Product Change Notification

Change Notification #: 113546 - 00
Change Title: Intel® Server System R2216GZ4GC
PCN 113546-00, Product Design
Add Ground Studs, Update System Rear Panel,
750W Common Redundant Power Supply and
SAS Expander RES2CV240 Firmware
Date of Publication: December 22, 2014

Intel is implementing the following changes on the Intel® Server System R2216GZ4GC:

Figure One

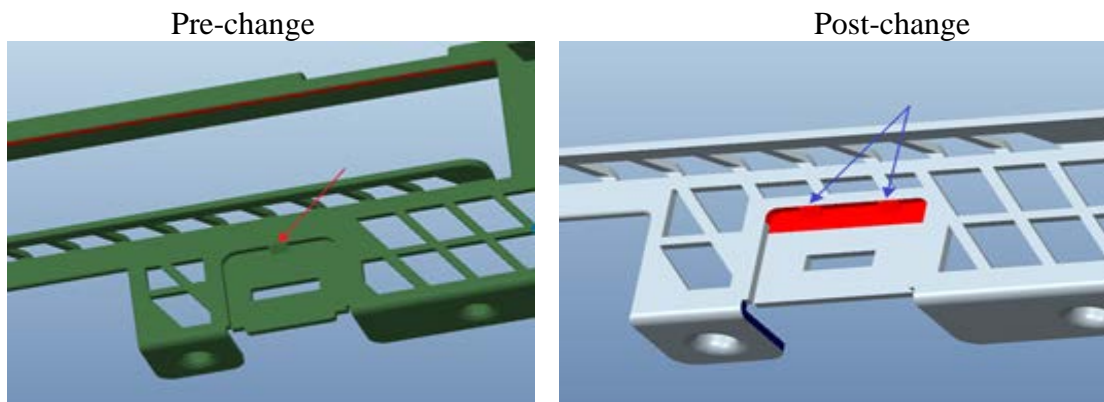
1. Update the one big center joint to two smaller joints so that the joints will not conflict with the LAN cable connector latch. See Figure One.

Figure Two

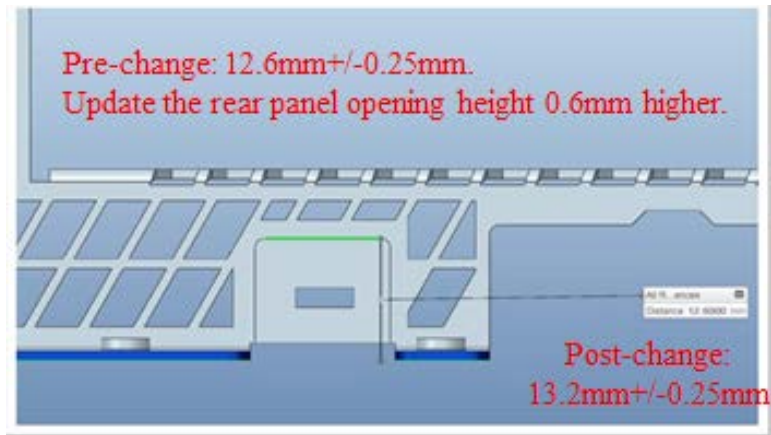
2. Update the rear panel opening height 0.6mm higher to improve the flexibility for the cable latch. The previous height was 12.6mm+/-0.25mm. The updated height is 13.2mm+/-0.25mm. See Figure Two.

Figure Three

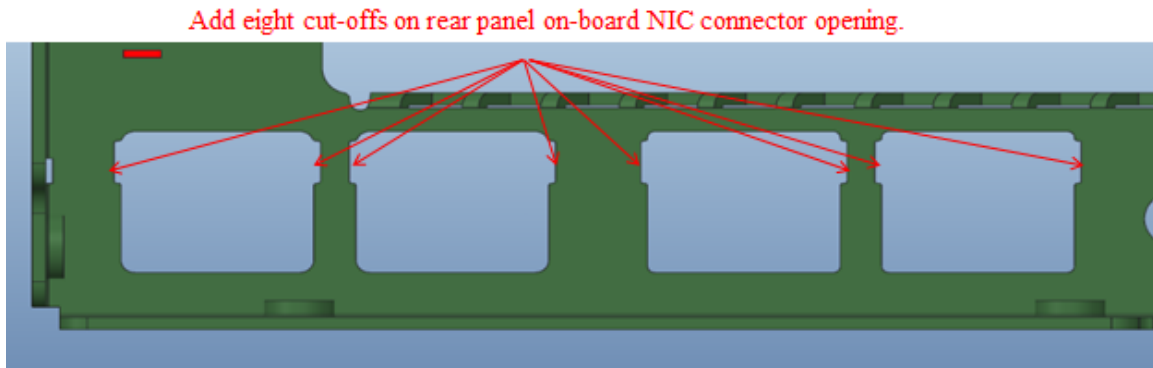
3. Add eight cut-offs around the on-board NIC (Network Interface Controller) openings to improve the LED visibility. See Figure Three.
